Agenda for 90th PCC Meeting

EASTERN REGIONAL POWER COMMITTEE

AGENDA FOR 90TH PROTECTION SUB-COMMITTEE MEETING TO BE HELD ON 13.05.2020 AT 10:00 HOURS

Figure 1: Network across affected area

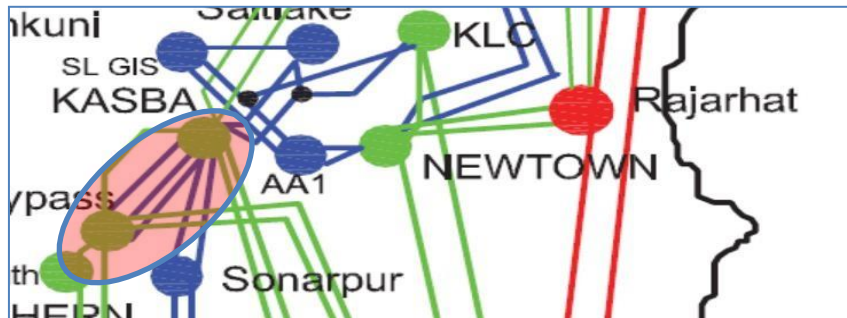
Reason and location of fault along with reason for delayed fault clearing may be shared. As per WBSLDC/CESC report, around 1.1 kA current in R phase for 300 ms. was flowing from EMSS to WBSECL system before islanding. No fault or tripping was reported in WBSETCL system at the time of fault. As per DR/PMU plot shared by CESC, around 0.5 kA current in R phase was flowing through 132 kV EMSS – Kasba – 3. CESC/WBSLDC are advised to share DR/PMU plots of 132 kV EMSS – Kasba – 1 and 2 also (WB SLDC/ CESC to update)

Figure 2: Three phase voltage recorded at Subhasgram PMU at the time of the disturbance shows delayed clearance of R phase to earth fault. Fault clearing time is around 300 ms.

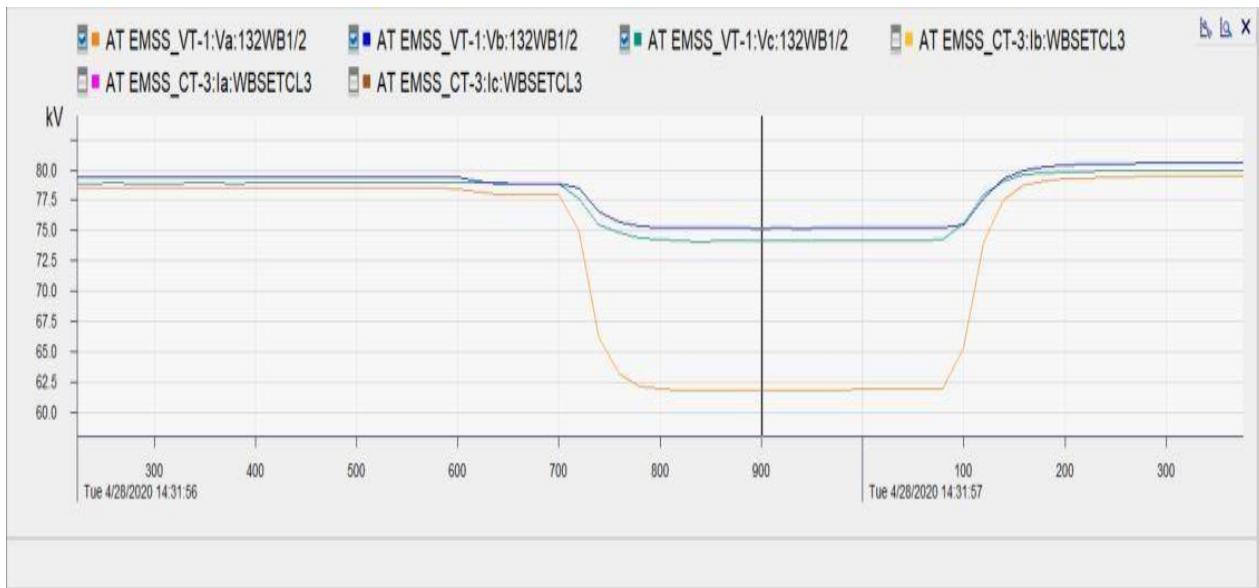
Prior to the event, CESC system was radially connected with rest of the grid via 132 kV Kasba (WBSETCL) – EMSS T/C. At 14:31 hrs, 132 kV Kasba (WBSETCL) – EMSS T/C tripped only from EMSS end resulting in islanding of CESC system along with generation units #1, unit #2 and unit #3 at Budge Budge generating station. No load or generation loss was reported at the time of the event. R phase to earth fault was observed in Subhasgram PMU data and fault clearing time was around 300 ms. Detailed analysis is attached in **Annexure B24.2**
